Steps Required to Make CR4/CR10 Into Interoperable Standard

IEEE P802.3ba

Jan 13 2009

Ali Ghiasi
Broadcom Corporation
aghiasi@broadcom.com

What Must be Defined for TP2

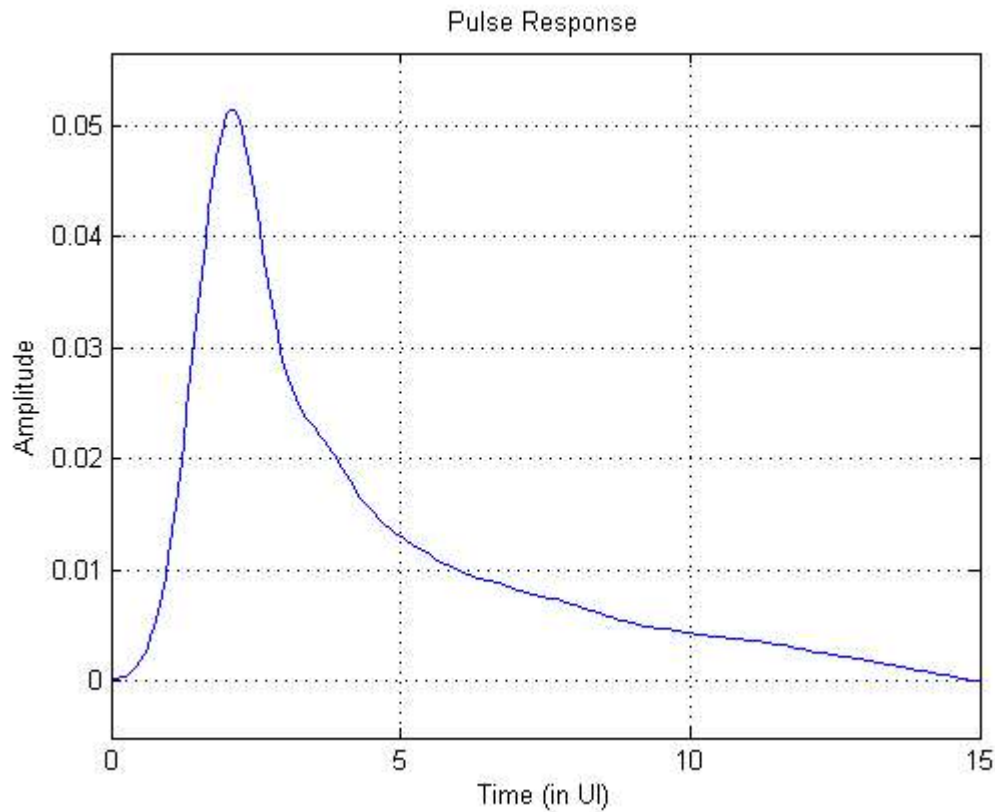
- **SFF-8431 approach can be utilized see Appendix E.2**
 - <ftp://ftp.seagate.com/sff/SFF-8431.PDF>
 - Other approach are acceptable as long as the method can be applied to real hardware.
- **TP2 parameters required for compliance are missing**
 - Output VMA suggest start with 360 mV p-p
 - Transmitter Qsq suggest start with 56 linear
 - Transmitter waveform penalty based on TWDP with value TBD
 - TWDP code convolves output waveform with cable impulse response to
 - determine the penalty.
 - Output AC common mode suggest start with 12 mV
